Summary of Findings

**Coachman Creek Condominium Association, Inc.
Buildings 1 through 28
2625 State Road 590
Clearwater, FL 33759
Claim Number: 4160072**

Regarding: Summary of Findings Buildings 1 through 28
Coachman Creek Condominium Association, Inc.
2625 State Road 590
Clearwater, FL 33759
Claim Number: 4160072

Figure 1 – 1952 Historical Aerial Photograph

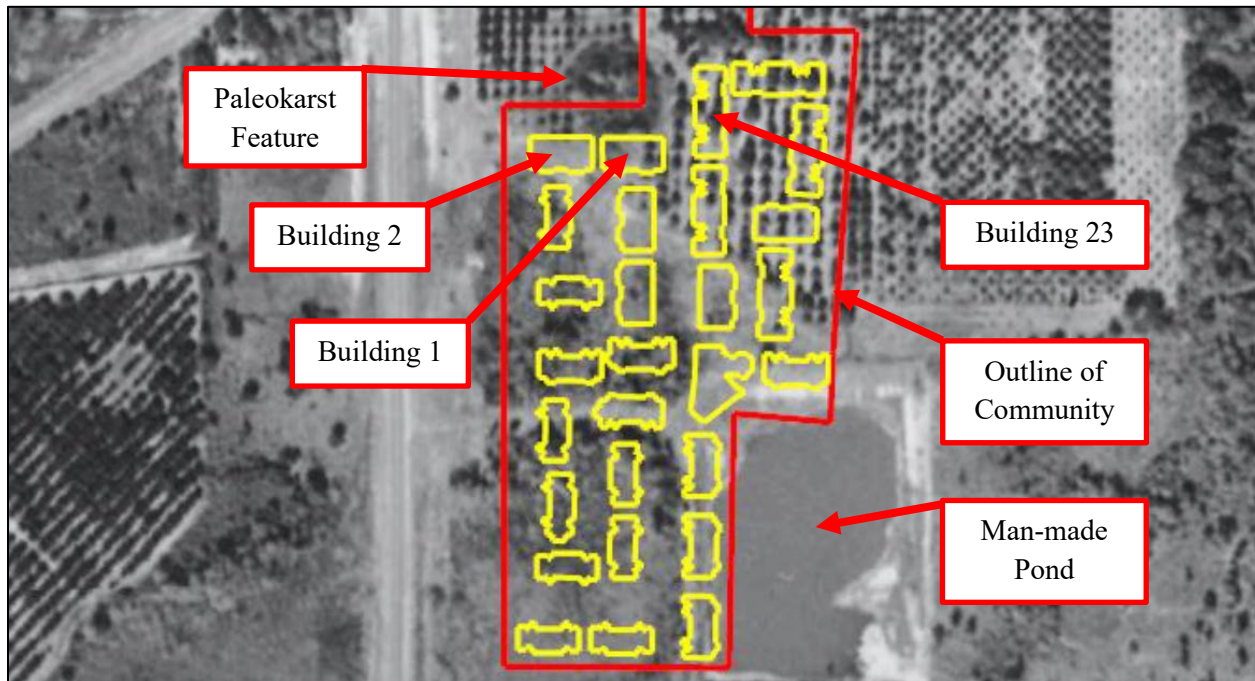
- a. Circa 1943, the subject community appeared to have been primarily undeveloped and part of an agricultural area with circular and irregular shaped closed depressional / wetland features in the surrounding area. Particularly, a circular depressional feature reminiscent of a paleokarst feature was located adjacent to Building 1, Building 2, and Building 23. Additionally, the north portion of Building 1 and Building 2 appeared to be overlying the paleokarst feature, as shown in the 1952 historical aerial photograph below in **Figure 1**.

- b. In the 1952 aerial, as shown in **Figure 1**, it appears that a man-made pond was created at the southeast portion of the property.
 - c. In 1962, it appears that most of the vegetation was removed in the northern section of the property in preparation for residential development.
